Yatala Central Business Park

Industry Development Building 7 at Christensen Road Stapylton
Location Plan

4 September 2007
Jimmy Duncan
Implementation & Assessment Branch, Nerang
(07) 5582 8866
4221-06 DRH/DMJ
PN289803/01/DA2
Application No: MCU2700123

NEGOTIATED DECISION NOTICE TO APPLICANT
APPLICATION TYPE: REQUEST FOR A NEGOTIATED DECISION NOTICE (S3.5.17)
FOR A MATERIAL CHANGE OF USE APPROVAL FOR AN INDUSTRY
PROPERTY DESCRIPTION: LOT 334 ON SP169272
PROPERTY SITUATED AT: CHRISTENSEN ROAD SOUTH, STAPYLTON

063044 A0001/P7
PRELIMINARY

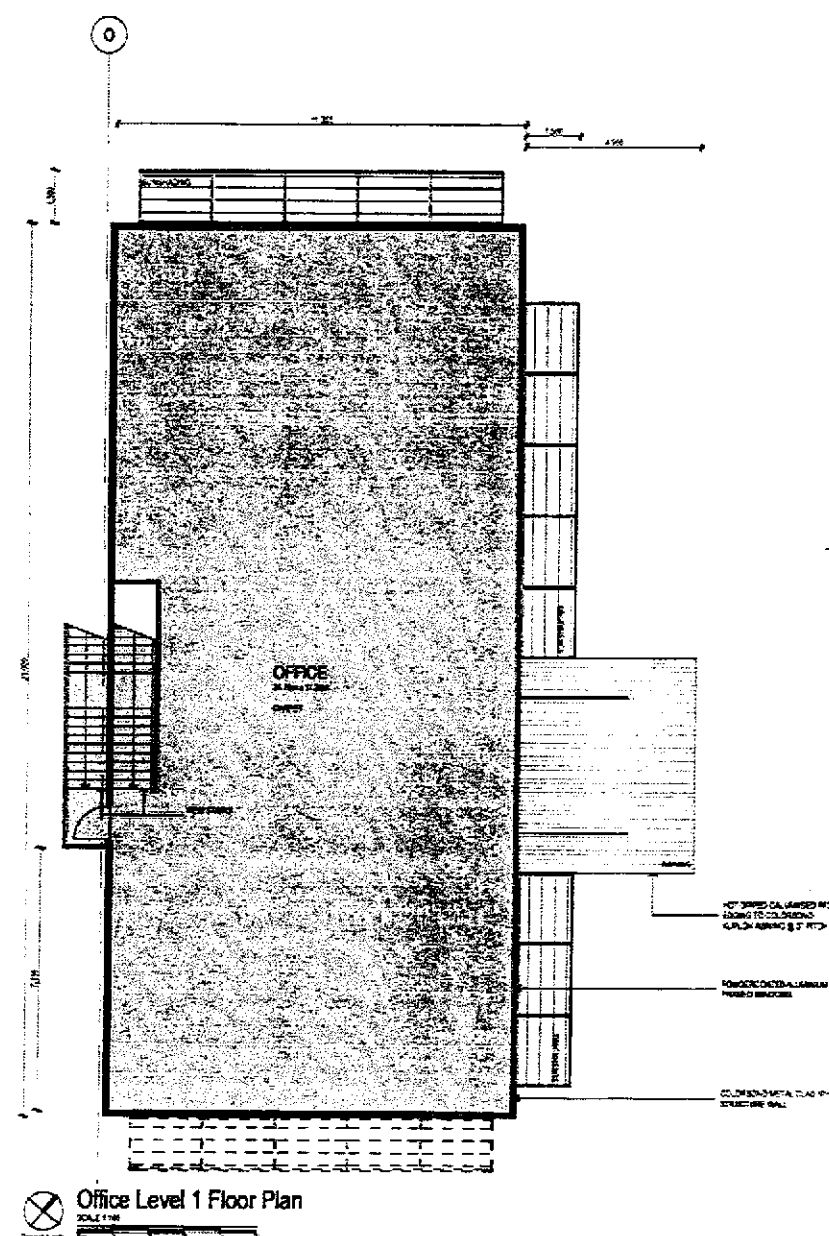
Condition 1(a) which currently reads:

- a. Amend Site Plan (A0001/P7) to demonstrate that vehicle access Type 7 crossovers can be provided in accordance with Gold Coast City Council's Standard Drawing No. 05-02-301.***

Shall be deleted.
